LiDAR Quality Assessment Report

WI Bayfield Co 2015

NGTOC
2017-01-25
S. Ruhl

Checkpoint Distribution Image

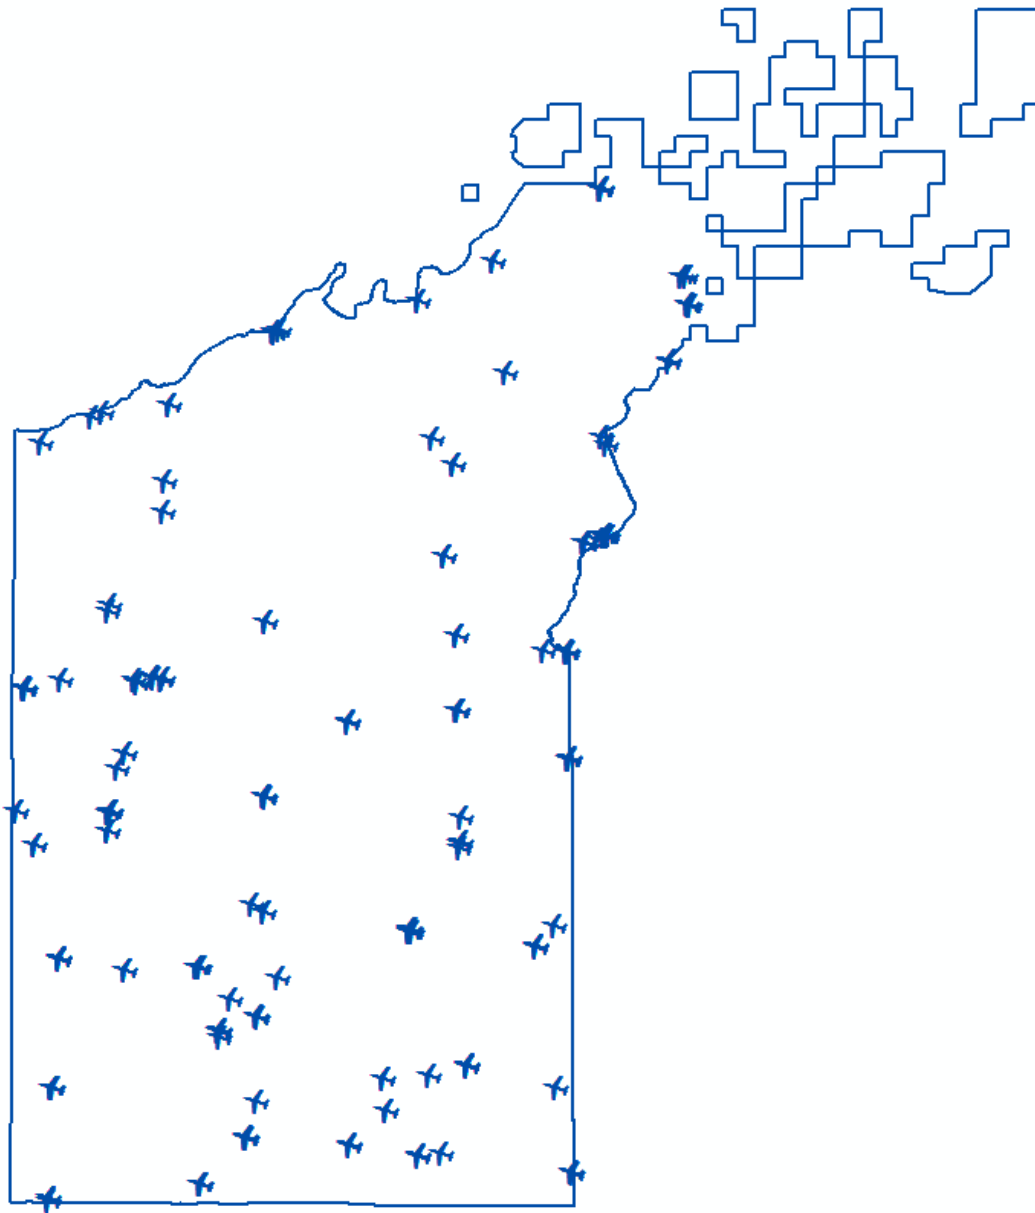
Vertical Accuracy Results:

Based on this review, the USGS accepts the vertical accuracy.

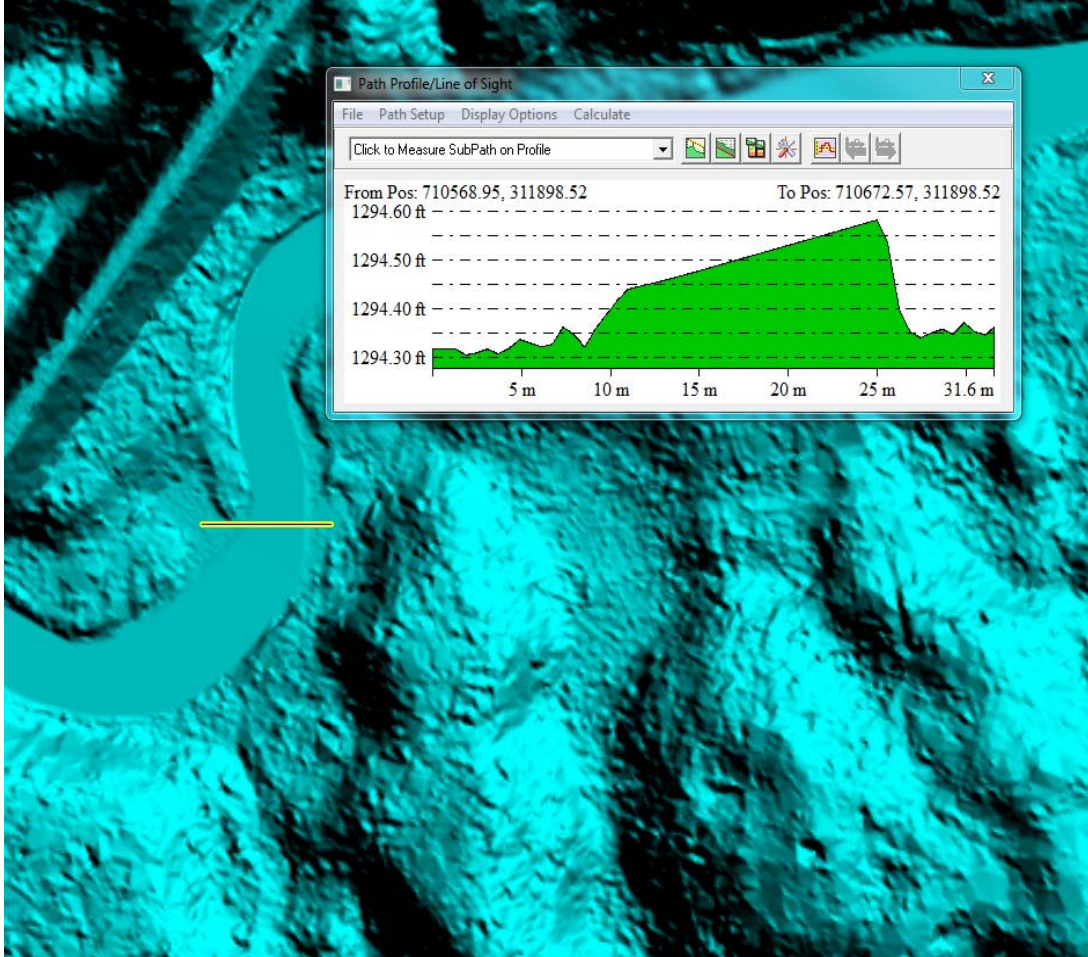
DEM Errors:

1 - floating area remaining @ **46° 11' 18.0810" N, 91° 18' 29.7120" W**

Some streams less than 100 in width have been flattened

1 of 1 floating still remaining @ 46° 11' 18.0810" N, 91° 18' 29.7120" W
